APPLICATION NO.	FILING DATE	FIRST NAMED INVENTOR	ATTORNEY DOCKET NO.	CONFIRMATION NO.
10/797,839	03/10/2004	John R. Blake	47171-00390USPT 5664	
41230 CLIMMINIS A	7590 10/17/2007 LLISON CORP.		EXAMINER .	
	EABODY LLP		MCCLAIN, GERALD	
161 N. CLARK ST., 48TH FLOOR CHICAGO, IL 60601		•	ART UNIT	PAPER NUMBER
CITICAGO, IL	, 00001	•	3653	
				·
			MAIL DATE	DELIVERY MODE
	•		10/17/2007	PAPER

Application No.	Applicant(s)				
	10/797,839	BLAKE ET AL.				
Office Action Summary	Examiner	Art Unit				
	Gerald W. McClain	3653				
The MAILING DATE of this communication appears on the cover sheet with the correspondence address Period for Reply						
A SHORTENED STATUTORY PERIOD FOR REPLY WHICHEVER IS LONGER, FROM THE MAILING DY.  - Extensions of time may be available under the provisions of 37 CFR 1.13 after SIX (6) MONTHS from the mailing date of this communication.  - If NO period for reply is specified above, the maximum statutory period was realized to reply within the set or extended period for reply will, by statute, Any reply received by the Office later than three months after the mailing earned patent term adjustment. See 37 CFR 1.704(b).	ATE OF THIS COMMUNICATION 36(a). In no event, h

FIG. 4

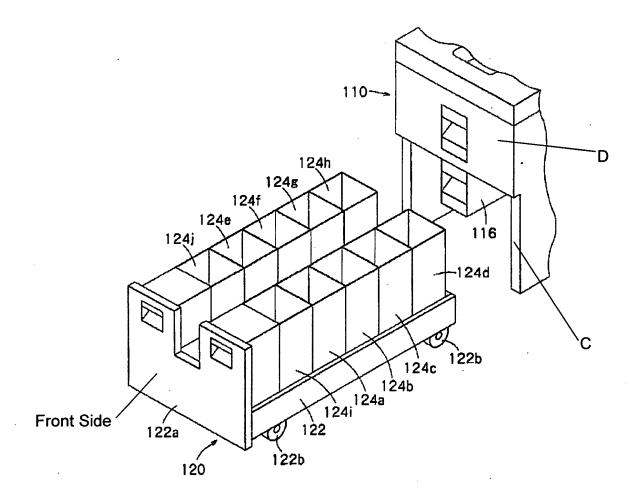
Claim 1: housing (See FIG. 2, 110); coin sorter (S); input hopper (112); rotatable disk (2); stationary head (1); lower surface ([0137]); shaped regions (10); exit channels (8a to 8c); coin receptacle station (120); coin receptacles (124a to 124j); first position (FIG. 2); second position (FIG. 4); manifold (location of 152); coin paths (152); dampening mechanism (See FIG. 4 below, C and 122a);

Claim 4: dampening mechanism (See FIG. 4 below, C and 122a); coin receptacle station (120); first end (See FIG. 4 below, C); housing (110); second end (See FIG. 4 below, Back Side (opposite Front Side) of 122a).

Claim 15: door (122a); rear side (See FIG. 4 below, D); housing (See FIG. 2, 110);

Claim 16: door (122a); front side (See FIG. 4 below, D; Note: the location of D can be defined as the rear or front side); housing (See FIG. 2, 110);

Claim 1 does not state in what direction the damping force is exerted or in what operation (closing or opening). In the closing operation there is a damping force exerted.
